## APPENDIX A

#### Consent Order, *United States v. Lanier Pointe, LLC, et al.* (E.D.NC.)

**APPENDIX C**  
**RETROFIT PLAN FOR COTTAGES AT AZALEA APARTMENTS**

**APPENDIX D**  
**RETROFIT PLAN FOR AZALEA GARDENS APARTMENTS**

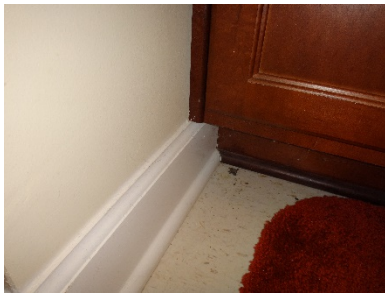
20	 <p><i>Entrance door threshold exterior side at Unit 120B.</i></p>	<p>Door thresholds are more than 3/4 inches high at the exterior face and are not beveled (maximum 3/4 inch with bevel allowed).</p>

<u>Location</u>	<u>Height (inches)</u>	Unit 117C, storage	1-3/8	Unit 120B, entrance	1	<p>At unit entry doors: Provide beveled transition strips.</p> <p>At storage doors: Provide beveled transition strip or offer remediation upon request of tenants. If offered on tenant request, a durable-material placard, contrasting black text on white background, in minimum 14-point font, must be placed on the side of the patio door stating: “A BEVEL TO ASSIST PERSONS WITH DISABILITIES FOR THIS</p>
<u>Location</u>	<u>Height (inches)</u>								
Unit 117C, storage	1-3/8								
Unit 120B, entrance	1

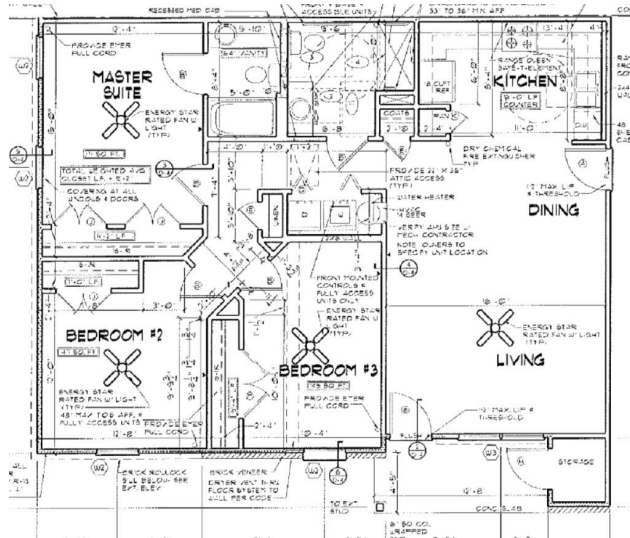
23	 <p><i>Storage door threshold exterior side at Unit 116C.</i></p>	<p>Door thresholds are more than 3/4 inches high at the exterior face and are not beveled (maximum 3/4 inch with bevel allowed).</p> <table><tr><td>Location</td><td>Height (inches)</td></tr><tr><td>Unit 116C, storage</td><td>1-1/2</td></tr></table>	Location	Height (inches)	Unit 116C, storage	1-1/2	<p>Provide beveled transition strip or offer remediation upon request of tenants. If offered on tenant request, a durable-material placard, contrasting black text on white background, in minimum 14-point font, must be placed on the side of the patio door stating: “A BEVEL TO ASSIST PERSONS WITH DISABILITIES FOR THIS THRESHOLD IS AVAILABLE UPON REQUEST. CONTACT MANAGEMENT.”</p>
Location	Height (inches)						
Unit 116C, storage	1-1/2

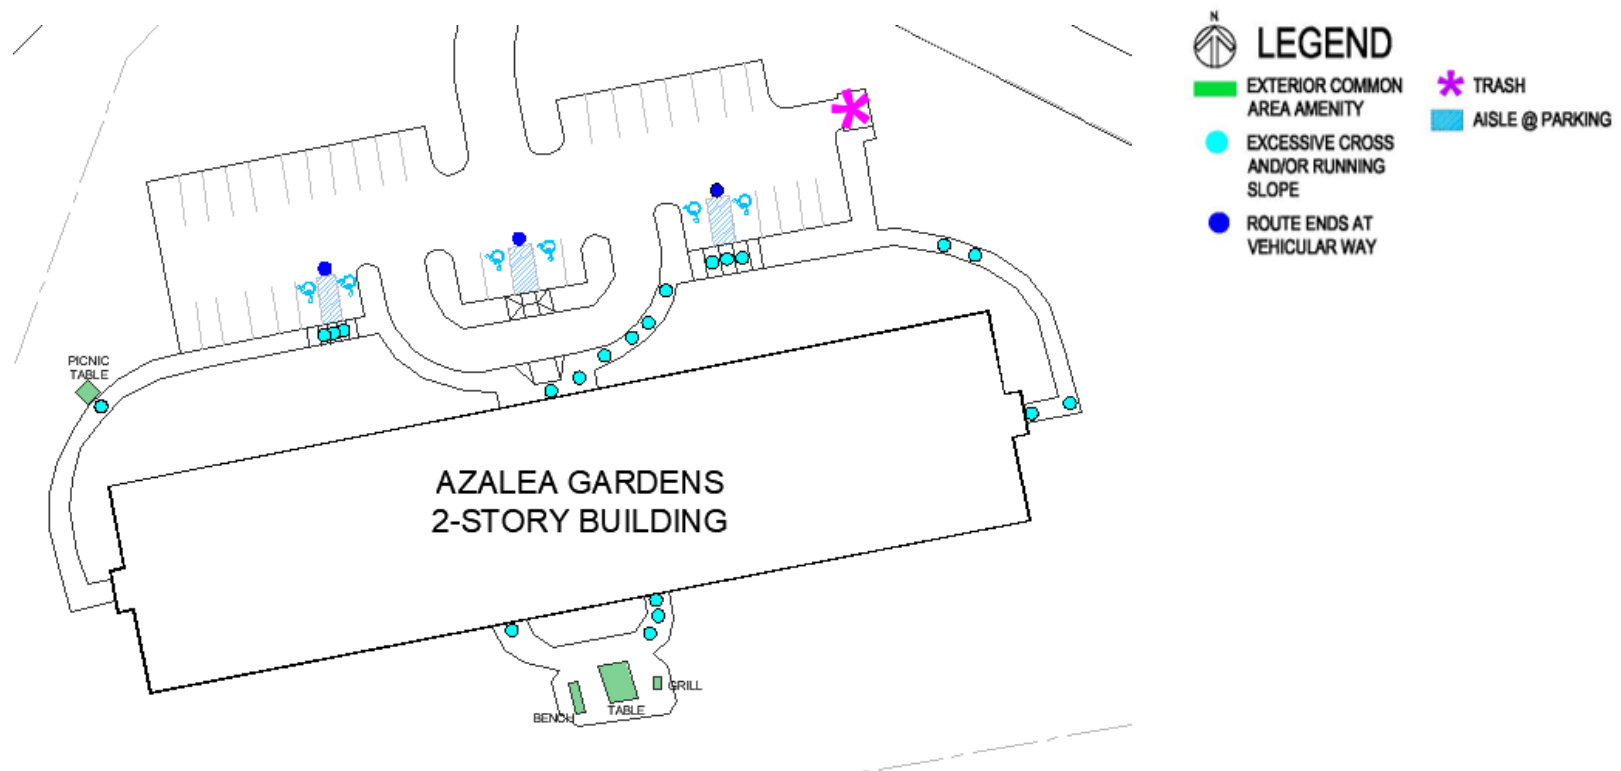
4	 <p><i>Handrail at ramp leading to building entrance.</i></p>  <p><i>Handrail at ramp leading to building entrance.</i></p>	<p>The ramp handrails at the main entry extend less than 12 inches beyond the ramp surface (minimum 12 inches required).</p>

<u>Location</u>	<u>(inches)</u>	Entrance ramp	1-1/2	Entrance ramp	1-1/4	Entrance ramp	4	Entrance ramp	4	<p>Remove handrails. Confirm that rise is 6 inches or less.</p> <p>Note: if ramp rise exceeds 6 inches or if handrails are desired by property management, install new handrails with 12 inch extensions.</p>
<u>Location</u>	<u>(inches)</u>												
Entrance ramp	1-1/2												
Entrance ramp	1-1/4												
Entrance ramp	4												
Entrance ramp	4

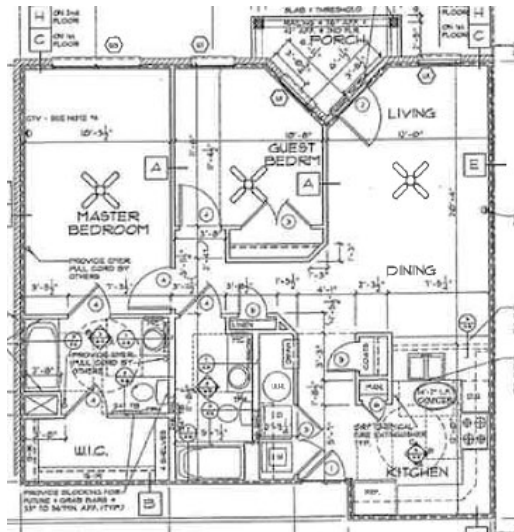
12	 <p><i>Patio door threshold interior side at Unit 204</i></p>	<p>Patio door interior threshold is 3/4 inches high at the front edge and is not beveled (maximum 1/4 inch vertical edge allowed with no bevel). The overall height of the threshold is 1-3/8 inches (maximum 3/4 inch height allowed).</p>	<p>Provide beveled transition strip or offer remediation upon request of tenants. If offered on tenant request, a durable-material placard, contrasting black text on white background, in minimum 14-point font, must be placed on the side of the patio door stating: “A BEVEL TO ASSIST PERSONS WITH DISABILITIES FOR THIS</p>
----	---	---	---

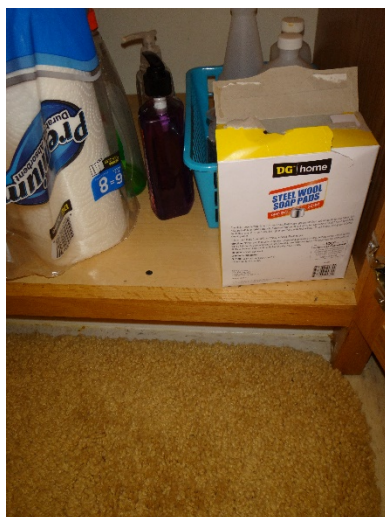
14	 <p><i>Patio door threshold interior side at Unit 214.</i></p>	Patio door interior threshold is 1-1/8 inches high at the front edge and is not beveled (maximum 1/4 inch vertical edge allowed with no bevel). The overall height of the threshold is 1-3/8 inches (maximum 3/4 inch height allowed).	Provide beveled transition strip or offer remediation upon request of tenants. If offered on tenant request, a durable-material placard, contrasting black text on white background, in minimum 14-point font, must be placed on the side of the patio door stating: “A BEVEL TO ASSIST PERSONS WITH DISABILITIES FOR THIS THRESHOLD IS AVAILABLE UPON REQUEST. CONTACT MANAGEMENT.”						
15	 <p><i>Center line of lavatory, Unit 214.</i></p>	<p>Lavatory centerlines are less than 24 inches to the side wall (minimum 24 inches required) and the cabinets are not removable.</p>

*Protruding height and lower fountain (standing fountain is approximately 3 inches higher).*

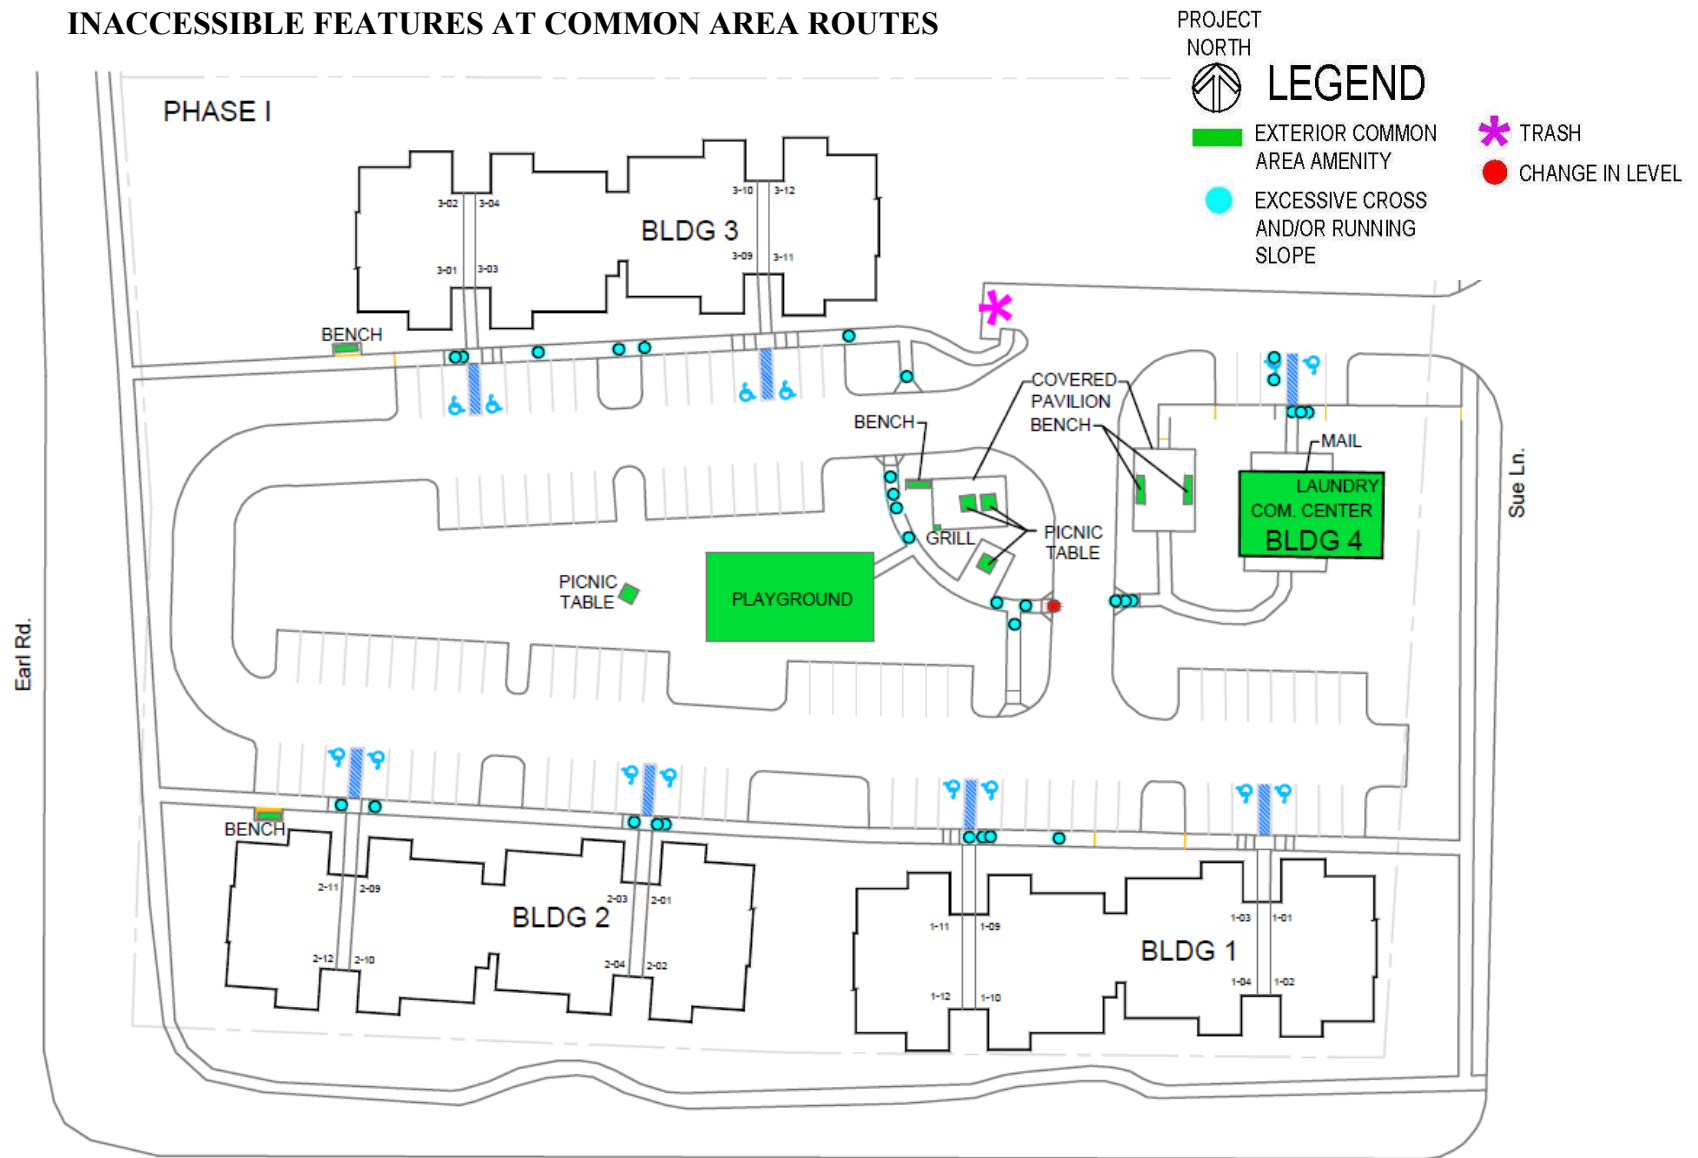
<u>Location</u>	<u>Protrusion (inches)</u>	Leasing Office		Standing height fountain	18-1/2	<p>Install shroud or other cane detectable barrier. Barrier may not obstruct required knee and toe space at lower unit.</p>
<u>Location</u>	<u>Protrusion (inches)</u>								
Leasing Office									
Standing height fountain	18-1/2

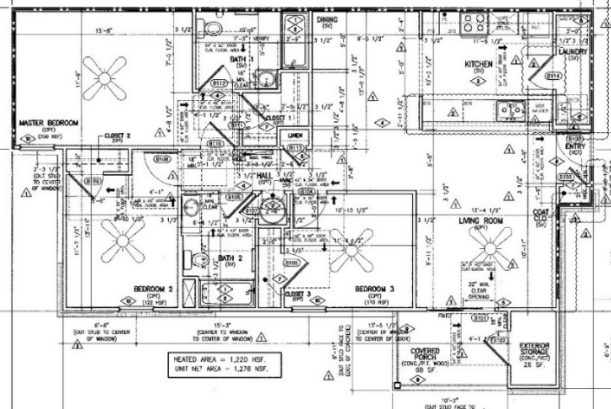
14		<p>The shape of the bathtub surrounds precludes the installation of future grab bars with firm attachment to blocking (ability to install grab bars required).</p>	<p>Replace tub surround or install custom grab bars on request that can be mounted in the required locations at the existing surrounds. If not replacing the tub surround, fabricate at least two custom grab bars for the tub back walls. Maintain a stock of two such grab bars on site at all times. Install on request at no charge.</p>
----	---	--	--

*Base of lavatory cabinet in  
Unit 2-03 hall bathroom*

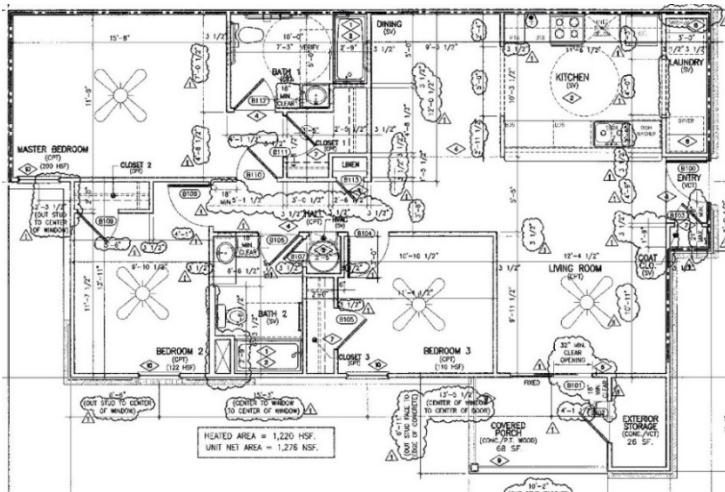
Attach a durable-material placard stating:  
“THIS CABINET IS REMOVABLE FOR PERSONS WITH DISABILITIES. CONTACT MANAGEMENT.”

*Projection from the wall.*

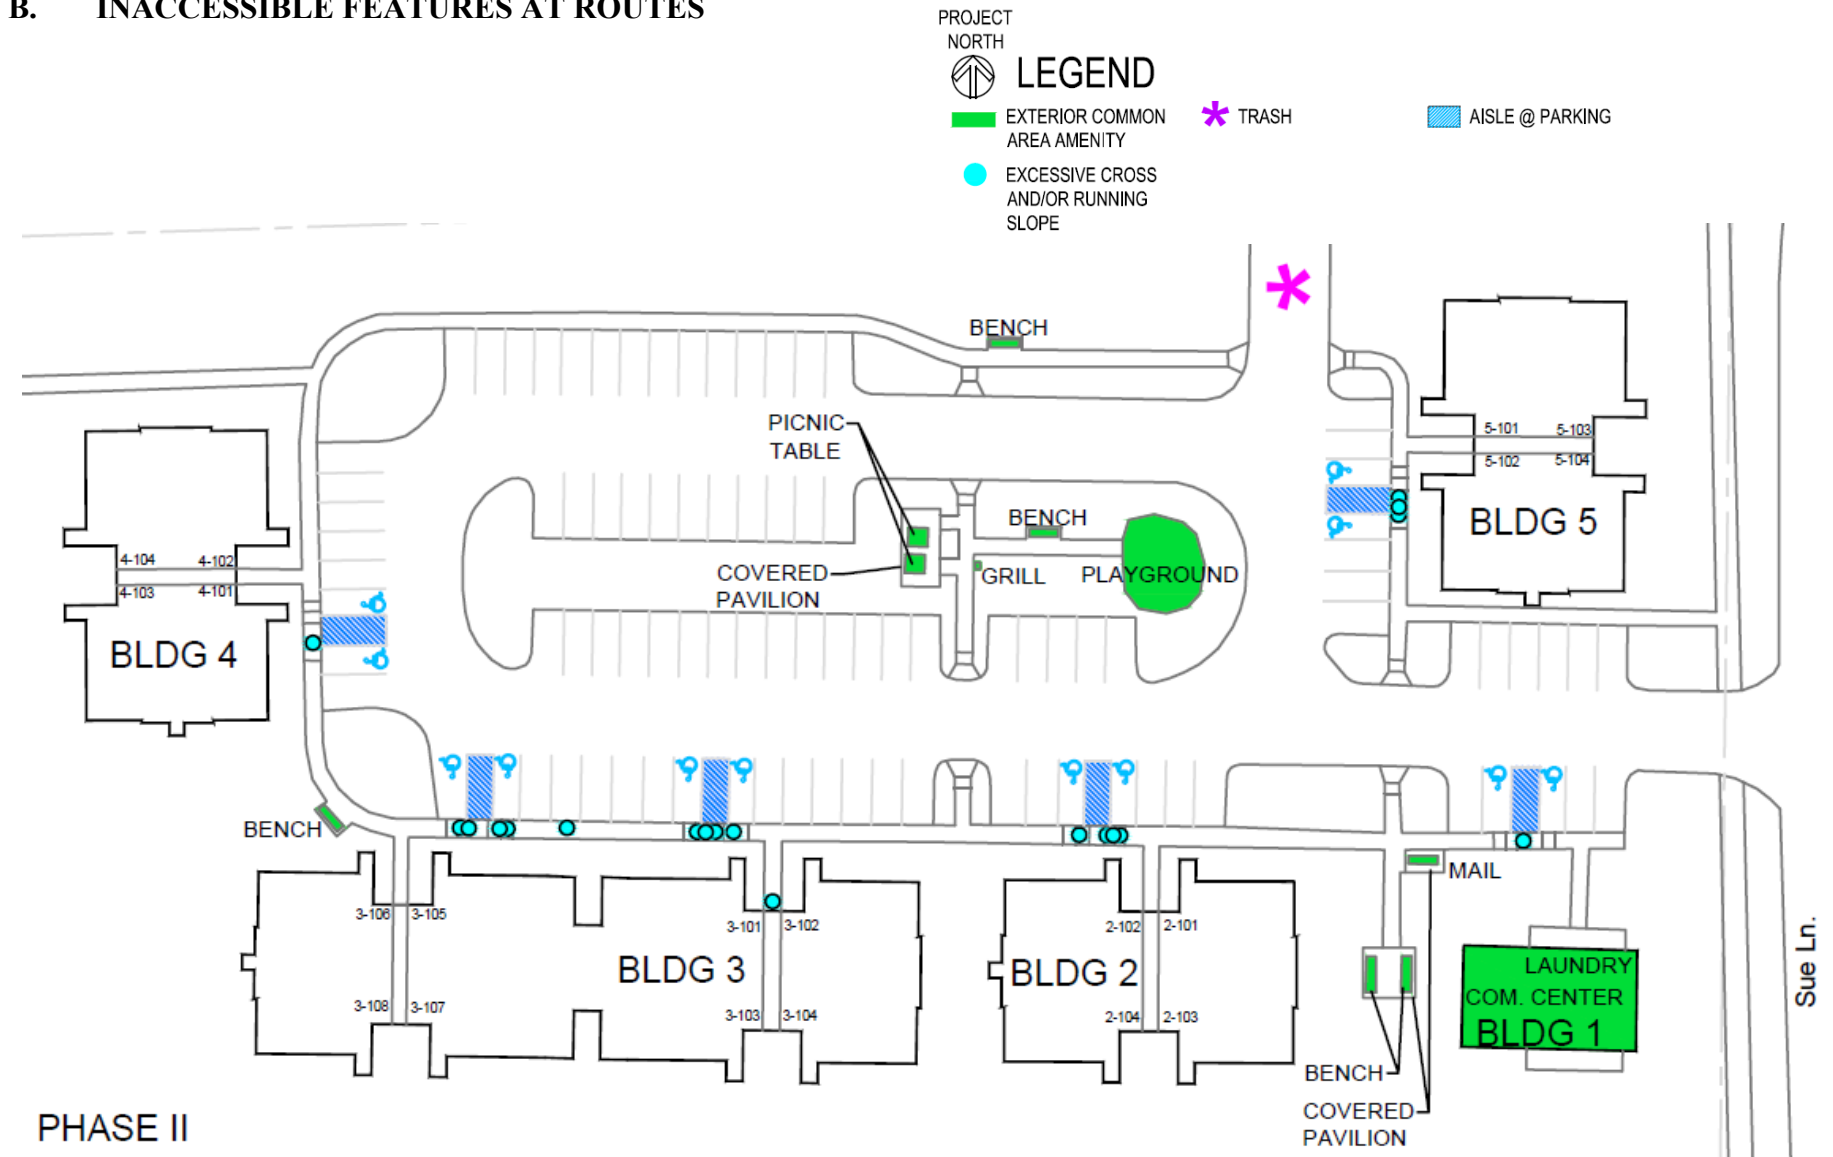
<b>Inaccessible Restroom Features</b>		
1	 <p><i>Flush control at women's restroom.</i></p>	Toilet flush control in the women's restroom is located on the side opposite the side of approach (not allowed).	Replace tank.
	<b>Protruding Object</b>		
2	 <p><i>Drinking fountain in community center.</i></p>	The leasing office/community center drinking fountain protrudes 19 inches into the circulation path at a height of 27-1/2 inches at the low fountain and at a height of approximately 31 inches at the high fountain (maximum 4 inch protrusion allowed at heights between 27 inches and 80 inches above the floor).	Install shroud or other cane detectable barrier. Barrier may not obstruct required knee and toe space at lower unit.

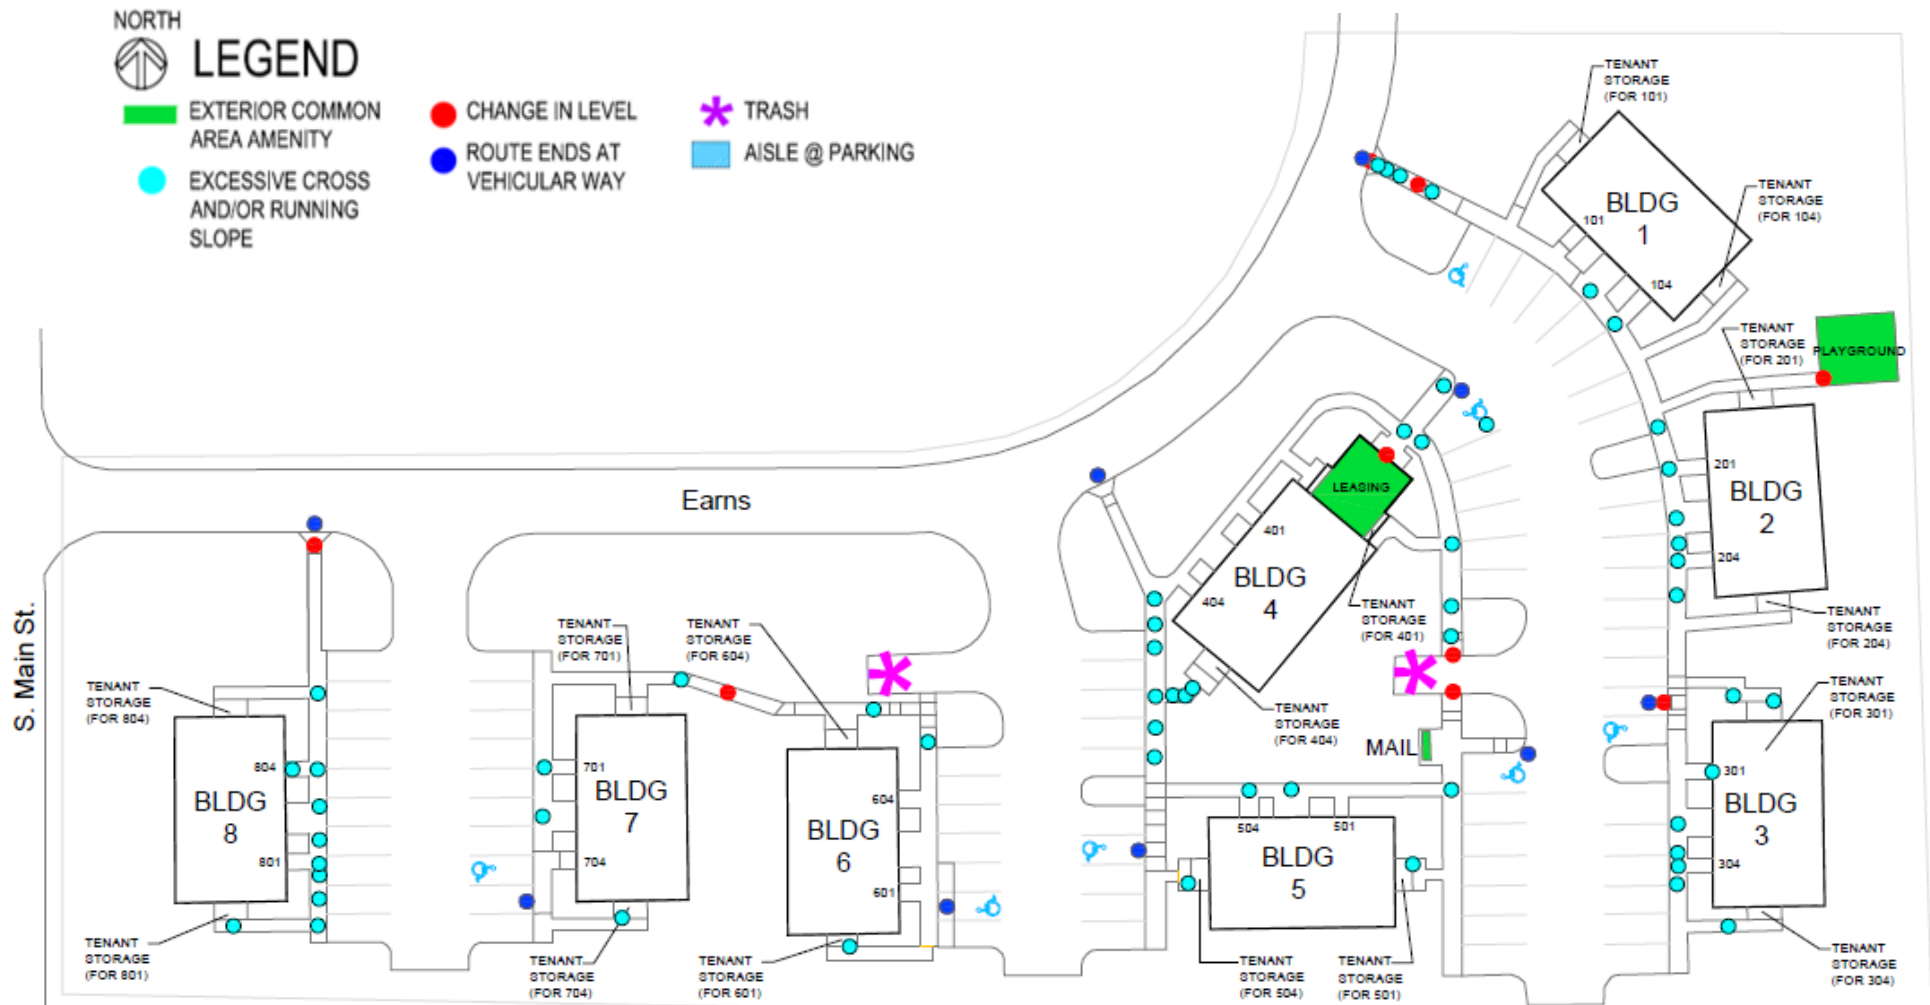
Inaccessible Thresholds								
7	<div><p><i>Interior threshold.</i></p><p><i>Exterior threshold</i></p></div>	<p>The leasing office door interior and exterior threshold heights are greater than 1/2 inch with no bevel (maximum 1/4 inch vertical allowed, 1/2 inch threshold height with bevel is allowed).</p>

<u>Location</u>	<u>Height (inches)</u>	Interior threshold	7/8	Exterior threshold assembly	1-3/8	Replace threshold.
<u>Location</u>	<u>Height (inches)</u>								
Interior threshold	7/8								
Exterior threshold assembly	1-3/8

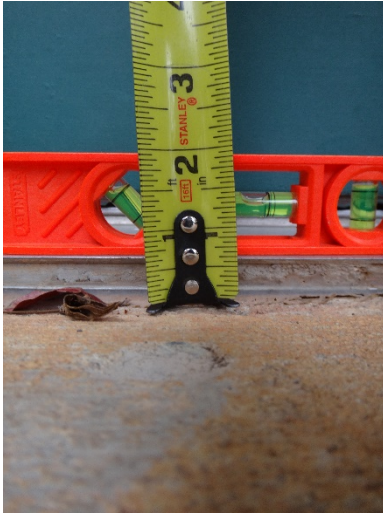
<b>Inaccessible Curb Ramp Features</b>										
15	<div><p><i>Curb ramp.</i></p><p><i>Cross slope.</i></p></div>	<p>Cross slope at curb ramps is more than 2.0% (maximum 2.0% allowed).</p>

<p>A maximum 2.0% cross slope is allowed. (Guidelines Requirement 2 Chart; ANSI 1986 4.8.6).</p>	<u>Location</u>	<u>Slope</u>	Curb ramp west of Building 1 bottom of ramp	6.0%	Curb ramp west of Building 1 parallel with curb	5.5%	Curb ramp west of Building 1 perpendicular to route	5.2%	<p>Replace concrete as required to retrofit sections with excessive cross slopes.</p>
<u>Location</u>	<u>Slope</u>										
Curb ramp west of Building 1 bottom of ramp	6.0%										
Curb ramp west of Building 1 parallel with curb	5.5%										
Curb ramp west of Building 1 perpendicular to route	5.2%
